Access Compliance Report

Public Rights-of-Way

Intersection ID: 30099	Main Street: LARWILL_LN	Cross Street: STONEFORT_CT	Location: SE
ADA ID: 51325A9071E4	Ramp Type: PerpDiag	Initial Pass/Fail: Fail	Overall Compliance: No
		Severity Score: 22.5

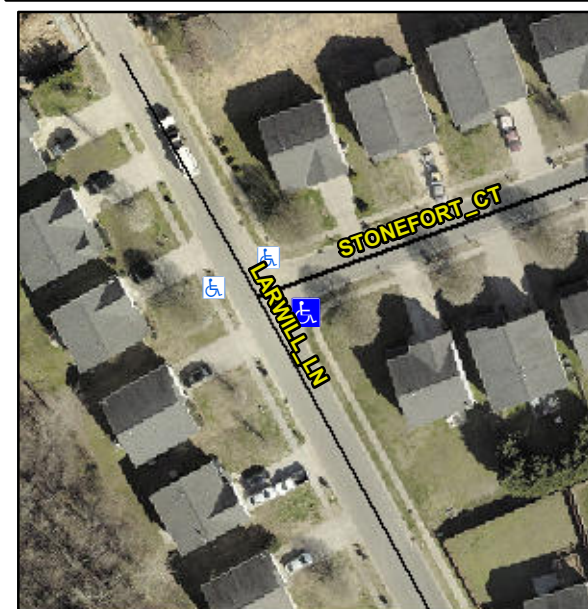
R304.5.1, R304.2.2, R304.5.3

Compliance	Description	Data	Compliance	Description	Data
N/A	Ramp Length (in)	47.0	No	Ramp Slope (%)	11.1
No	Ramp Width (in)	37.0	No	Ramp XSlope (%)	3.4
N/A	Flare Type LT	N/A	N/A	Flare Type RT	N/A
N/A	Flare Slope LT (%)	N/A	N/A	Flare Slope RT (%)	N/A
N/A	Flare Traversable LT?	N/A	N/A	Flare Traversable RT?	N/A
N/A	Landing Length (in)	N/A	N/A	DWS Provided?	N/A
N/A	Landing Width (in)	N/A	N/A	DWS Contrast?	N/A
N/A	Landing Slope (%)	N/A	N/A	DWS Length (in)	N/A
N/A	Landing X Slope (%)	N/A	N/A	DWS Full Width?	N/A
N/A	Landing Curb? (Y/N)	N/A	N/A	DWS Offset (in)	N/A
N/A	Shared Landing?	N/A			
N/A	Gutter Ponding?	N/A	N/A	Gutter Slope (%)	N/A
N/A	Gutter Lip Ht (in)	0.5	N/A	Gutter X Slope (%)	N/A
N/A	Painted X Walk1?	No	N/A	Painted X Walk2?	No
	X Walk 1 Direction	To N		X Walk 2 Direction	To W
N/A	X Walk 1 Width (in)	N/A	N/A	X Walk 2 Width (in)	N/A
	X Walk 1 Slope (%)	0.3		X Walk 2 Slope (%)	1.8
	X Walk 1 X Slope (%)	2.7		X Walk 2 X Slope (%)	0.4

Remove & Replace Curb Ramp With Two New Directional Ramps or Equivalent.
